**Instruction No. K14
Proposed Public Housing Redevelopment
at Pak Tin Estate (Phase 12)
Environmental Assessment Study (EAS)**

Draft Final Report (Revision 1)

Proposed Public Housing Redevelopment at Pak Tin Estate (Phase 12)
Environmental Assessment Study (EAS) EPD's comment regarding submission of the captioned EAS report (September 2023)

As built drawings for road side barrier along Nam Cheong Street

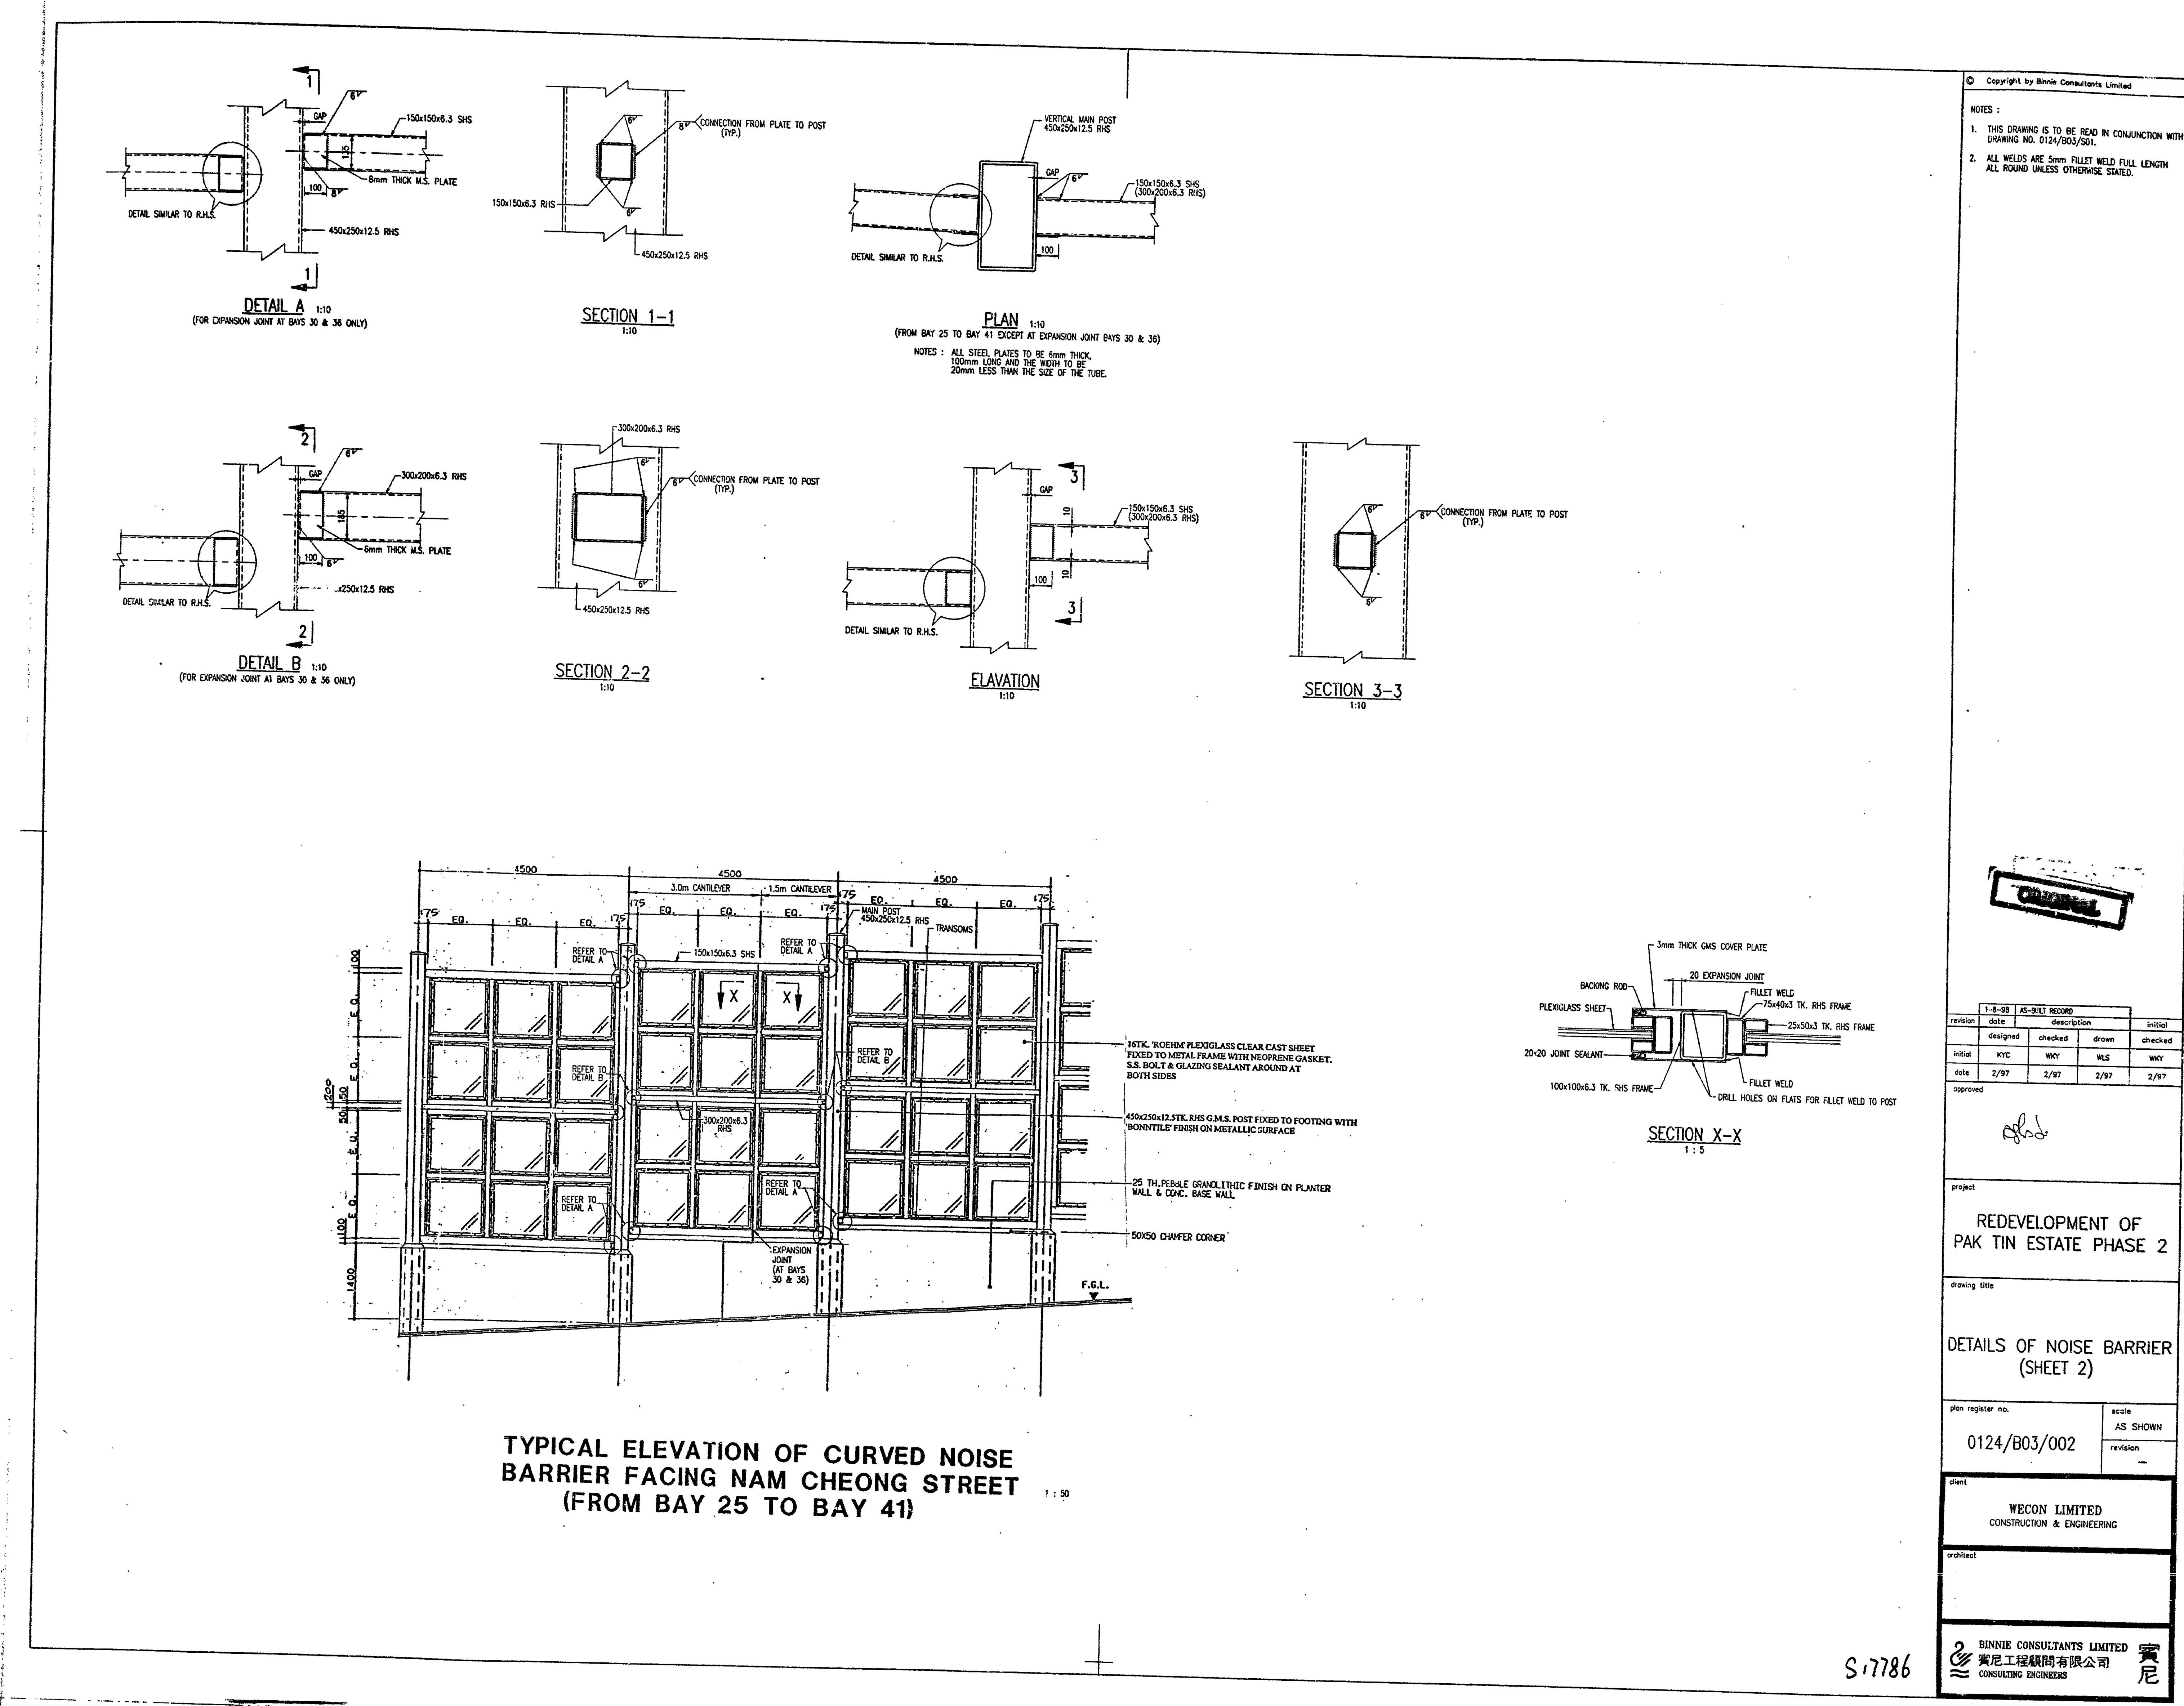
(b)	According to Section 2.3.7, the existing roadside noise barrier is 7m high. Please clarify and check if the height of a section of existing barriers opposite to Shek Kip Mei Park Sports Centre has been input correctly or not.	The noise model is rectified.
